August 11, 2025

**RE: Lot 1 Block 4 Volcano Cliffs Unit 19 SAD 228  
6556 Azor Ln. NW  
Grading and Drainage Plan Date: 4/19/2024  
Rev. Engineers Stamp Date: 8/1/2025 (D10D003T6)  
Case #: HYDR-2025-00278**

ENGINEER'S SEAL	<b>LOT 1 BLK 4 U 19 VC 6556 AZOR LANE</b>  <b>GRADING AND DRAINAGE PLAN</b>	DRAWN BY DEM
 DAVID SOULE P.E. #14522		DATE 4-18-24
	 Rio Grande Engineering ALBUQUERQUE, NM 87199 (505) 321-8099	6556 Azor Ln. DWG
		SHEET # C1
		JOB #

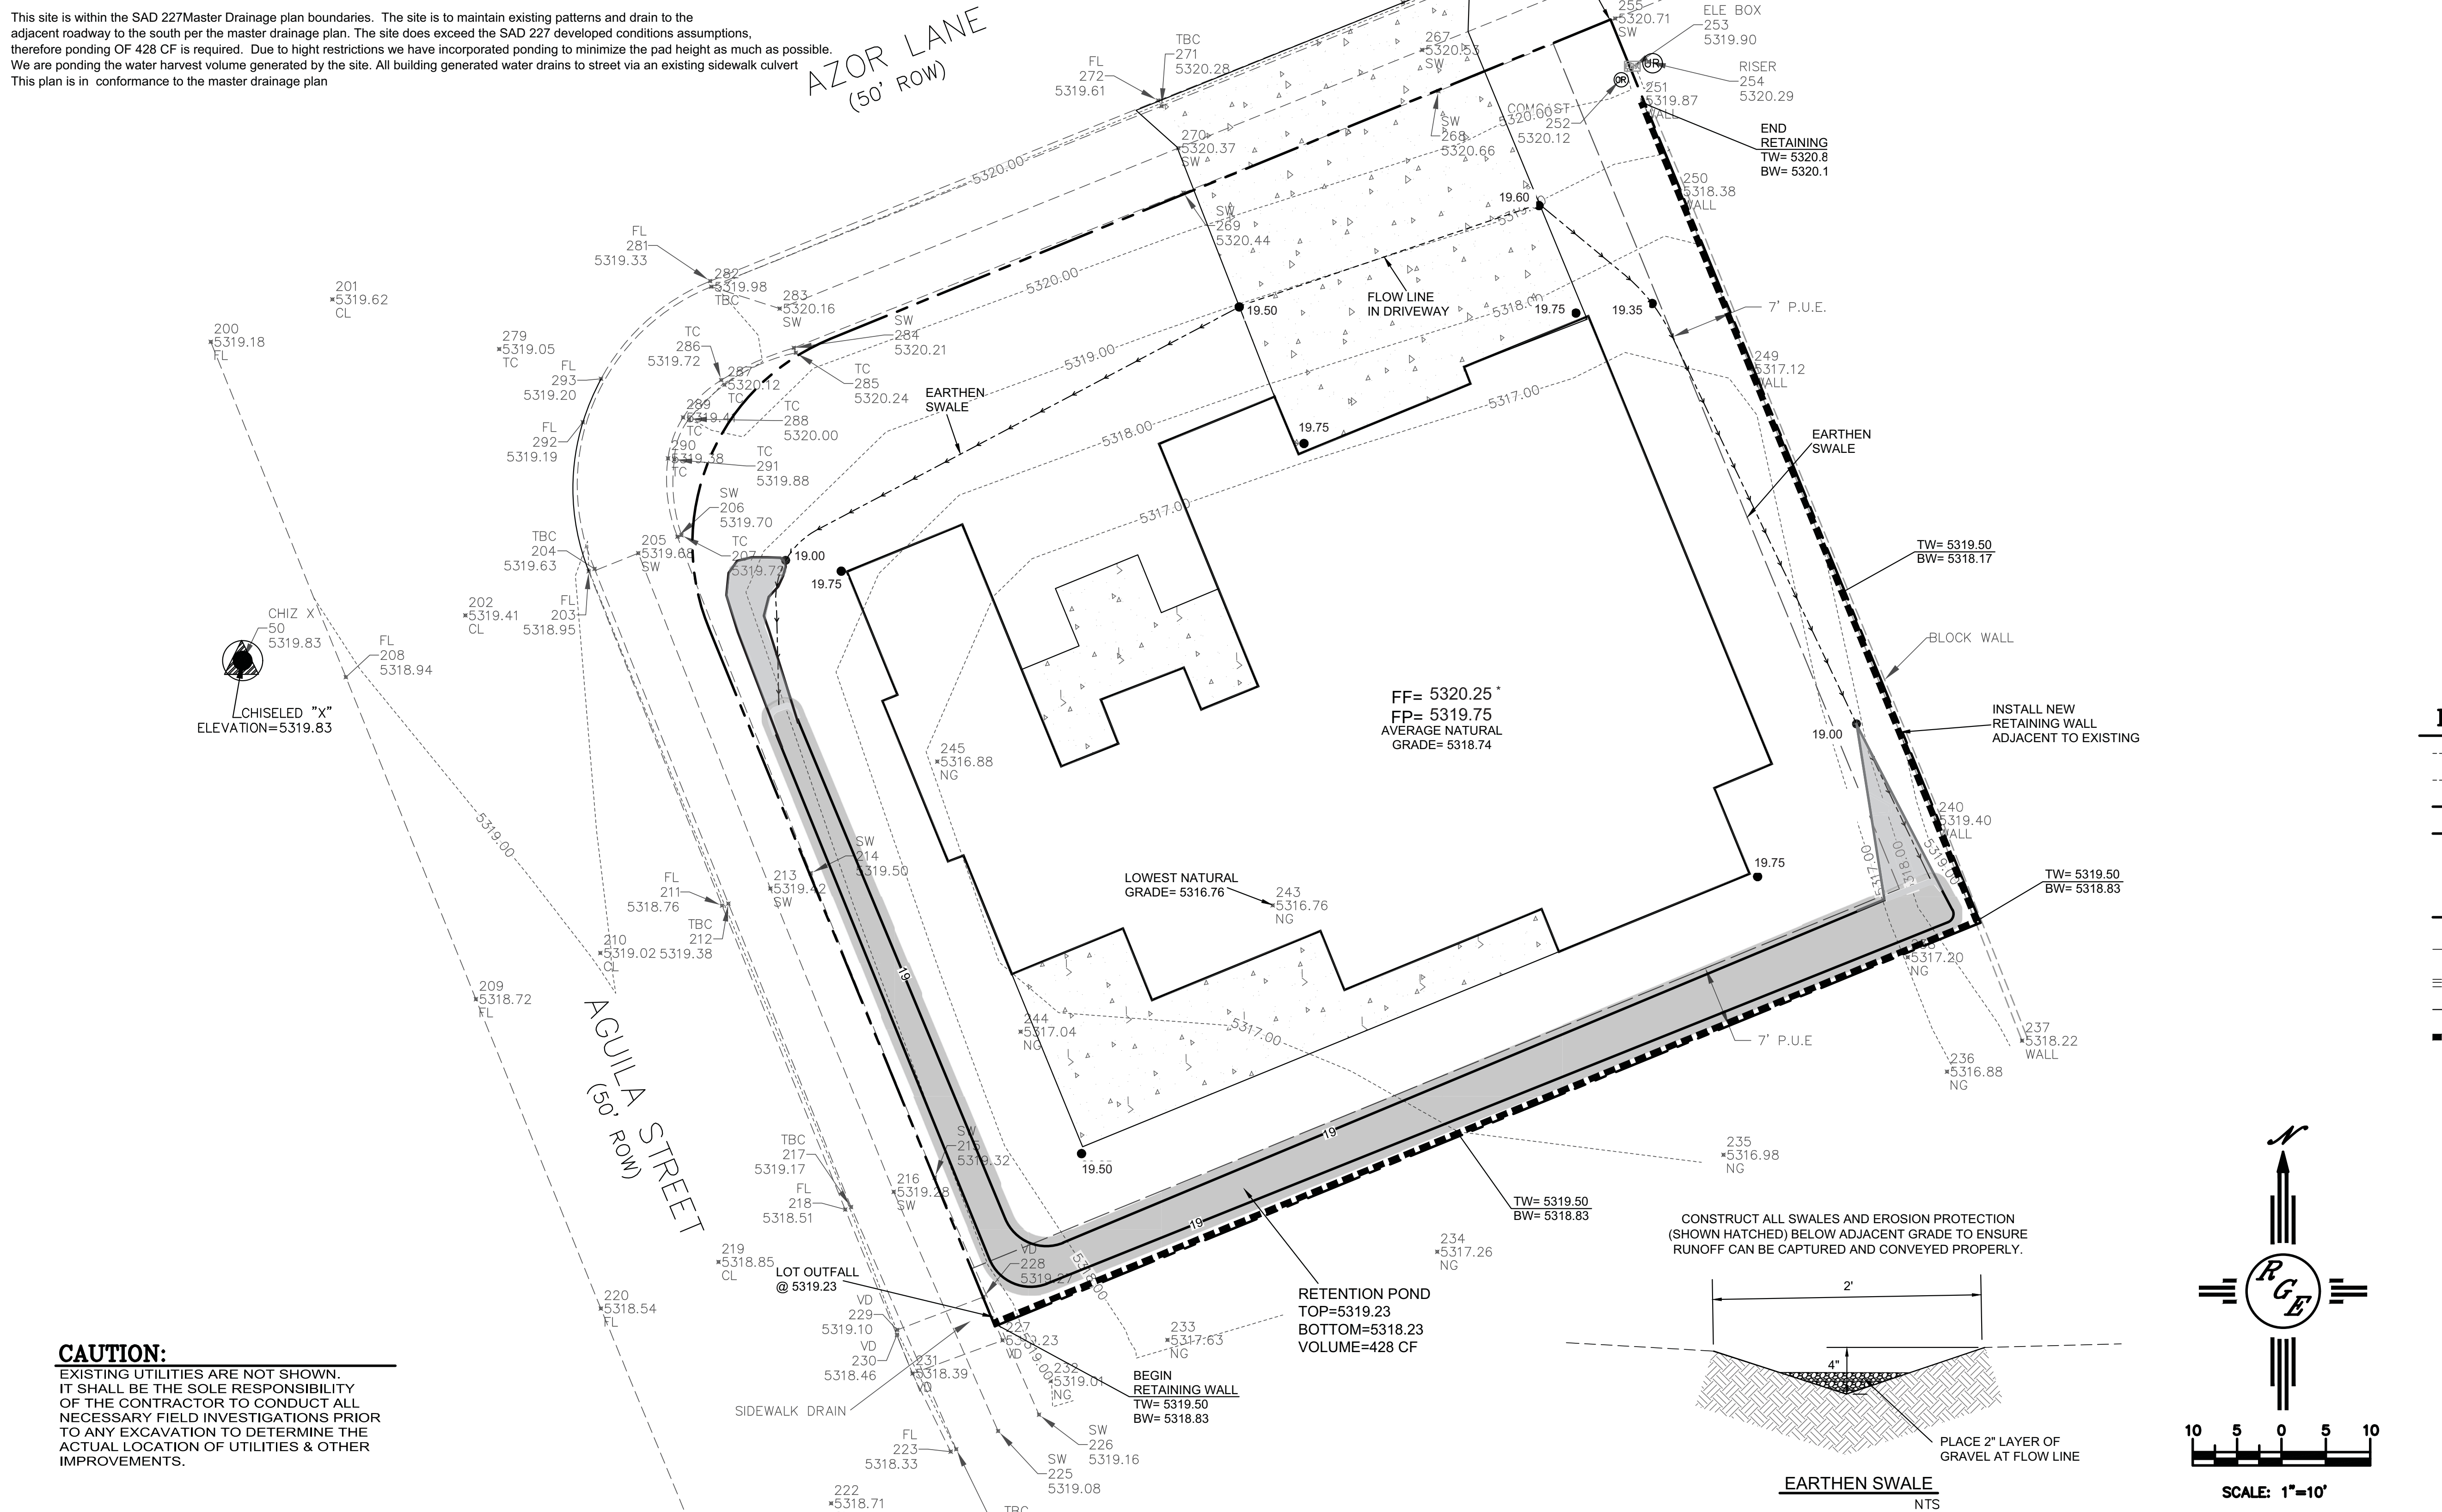
Based upon the information provided in your submittal received 8/11/2025, this plan is approved for a revised Grading Permit. **Dirt is not allowed to climb the curb, use crusher fines or lumber for this purpose.**

**Prior to Building permit approval a Pad Certification will be required, provided by the Engineer or a registered Land Surveyor.**

Reiterate to the Owner/Contractor that a separate permit for a garden/retaining wall must be obtained, with the approved G&D plan.

Prior to Certificate of Occupancy release, Engineer Certification per the DPM checklist of this plan will be required.
